Cub Cadet Service Advisory

SERIES 2000 TRACTOR

CC-396

Subject: 731-3150A HEADLIGHT REFLECTOR

INCORRECT PART 731-3150A

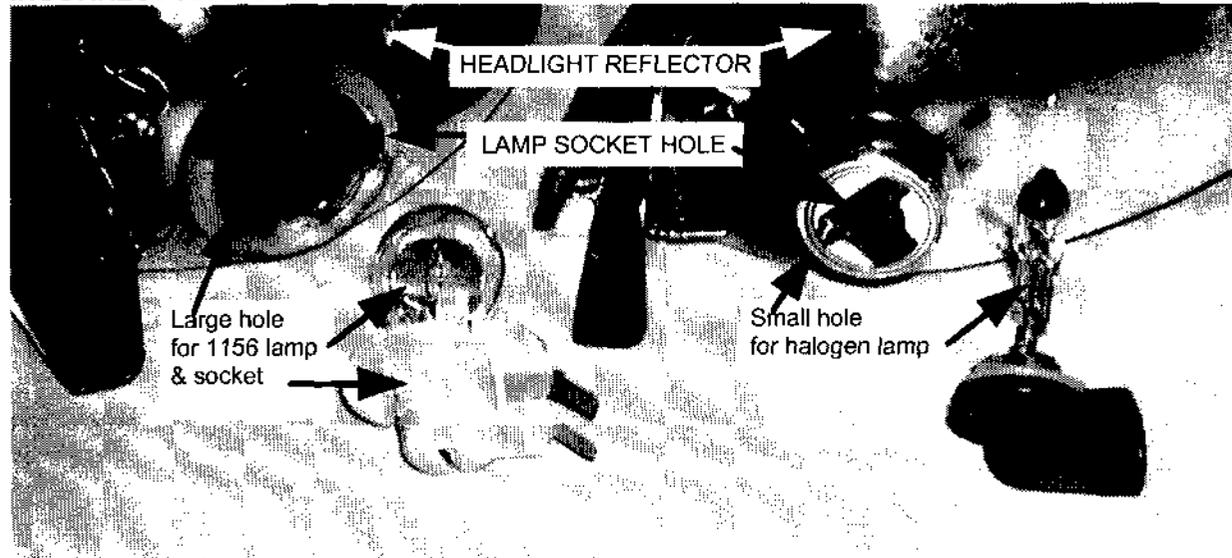
A few 731-3150A headlight reflectors, with wrong size lamp socket holes, have gotten into dealer inventories. This headlight reflector was used on Series 2000 tractors built prior to serial number/date code 1H019G.

Please check if you have any 731-3150A headlight reflectors in your parts inventory. If you do, check the size of the lamp socket hole. Refer to the picture below. Segregate any of the incorrect parts from stock and file a "FORM 8210" (REQUEST FOR RETURN OR CREDIT) to receive reimbursement for them. A blank form is being furnished for your convenience.

In the picture above, the headlight reflector on the left is used on Series 2000 tractors built after serial number/date code 1H019G. When this style headlight reflector is required for service, install part number 625-0053 or 925-0053 headlight assembly (includes lens, headlight reflector, 1156 lamp, and socket).

When existing inventories of the 731-3150A headlight reflector have been depleted, it will be discontinued. Service will then be performed by installing part number 725-3257A or 925-3257A headlight assembly (includes lens, headlight reflector, and halogen lamp).
